Interactive comment on “The sub-ice platelet layer and its influence on freeboard to thickness conversion of Antarctic sea ice” by D. Price et al.

D. Price et al.

Response to review 1:

Response to review number 2:

Fig. 1.

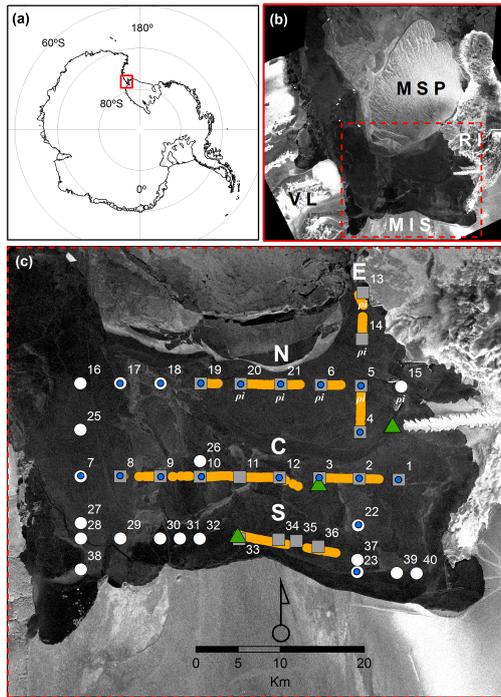
How was the information from the static GNSS stations used to correct for temporal variations? Was some sort of weighting used between the three stations based on distance? Was there a noticeable gradient in the three station values?

density measurements, and to have a justification as to why it was only measured at half of the sites.

Page 1006, lines 1-2 “The mean sea ice thickness as derived from all 39 drill-hole measurement sites” Previously the authors have stated that there were 40 drill hole sites (Page 1004, line 18: “Measurements were undertaken at 40 sites”), not 39. Fig. 1 and Fig. 3 only shows 39 drill hole sites (there is a site number 40, but not a site number 24). This inconsistency is confusing, and if there is a reason for it, it should be explained.

Page 1003, line 25-27 "Using an amended method at seven of our drill-hole sites in 2011 where no sub-ice platelet layer was measured we obtain a mean value [of i] of 927 kgm⁻³." This relates to the uncertainty discussed above regarding the authors' measurement of i . It is not clear from this statement whether i was measured at all sites, but with a different method used at the seven sites when the sub-ice platelet layer was absent, or if it was only measured at the seven absent sites. From Page 10011, line 23 it becomes clear that the former is the case, but this should be clearly stated in this section.

No noticeable spatial gradients in tidal influence were recorded between the three static GNSS stations. Temporal variations in the surface elevation measurements were corrected for by using the nearest GNSS station to the rover GNSS station at the time of acquisition.

The sentences in this section have now been amended to “In order to compensate for the tidal influence on the GNSS height and subsequently the SEGNS retrieval, three separate GNSS stations were deployed on the fast ice (see Figure 1 for locations). These tidal stations logged height information at 30 second intervals, which was subsequently down-sampled to 10 minute intervals. As the transit time of the mobile GNSS on the sea ice was hours, this information was used to correct the rover GNSS information for tidal height variation between drill-hole cross-over points. There was no discernible gradient in the tidal signal between the three tidal GNSS stations. Changes in elevation due to tides were taken from the closest tidal GNSS station to the mobile observation to correct SEGNS at the time of acquisition.”

The relevant sentence in the Figure 1 caption has also been amended to “The GNSS survey lines, Northern, Central, Southern and Eastern are indicated by the orange lines and tidal GNSS stations for tide correction by the green triangles.”

We agree that more information should be included. Snow density was measured at sites when there was enough time for the fieldwork team to do so given time constraints. The snow morphology was homogeneous. The sites at which it was measured are now indicated in Figure 1 as blue circles on sites. We have also amended the text to “For s we use the values measured in the field at 18 sites in McMurdo Sound in November and December 2011 (Figure 1) ranging between 281 and 461 kg m^{-3} . At sites where no data are available we use the mean value of all the measurements of 385 kg m^{-3} .”

This is a typo, there were only 39 measurement sites. This has now been amended in the text. Site 24 was a repeat site and therefore not included.

The locations of i measurements carried out in 2011 by the authors have now been indicated on the map in Figure 1.

This text was added to the Figure 1 caption "The 18 sites at which snow density was

measured are indicated with blue circles. The 7 sites at which sea ice density was estimated using the hydrostatic equilibrium assumption are shown with ' i ' underneath the measurement site."

Fig. 2.

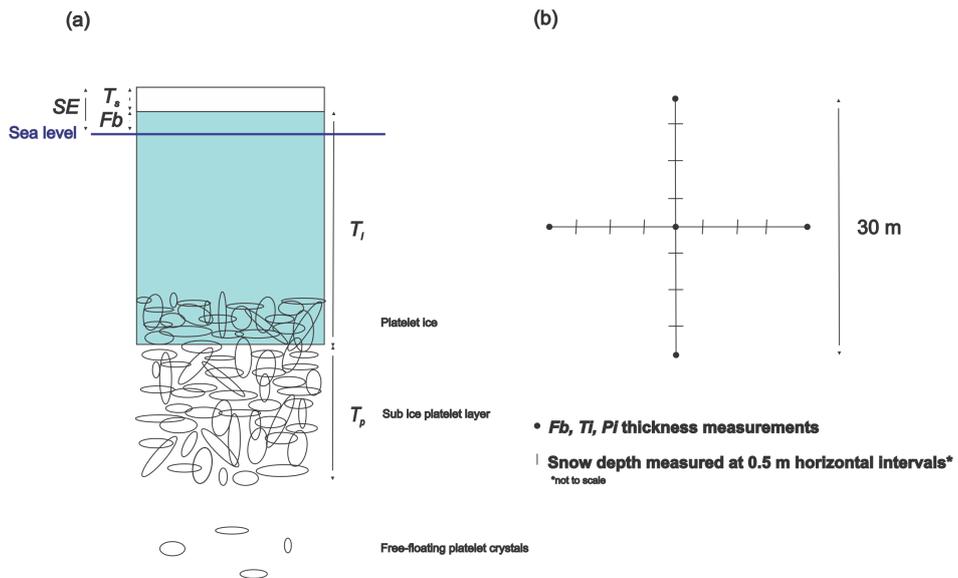
Figure 2: What is meant by 'snow depth measured at 0.5 m intervals', is this vertical or horizontal? Looks to be horizontal in the text, it would be good to state this in the figure.

This is snow depth as measured with a ruler at 0.5 m horizontal intervals. This has now been indicated in Figure 2.
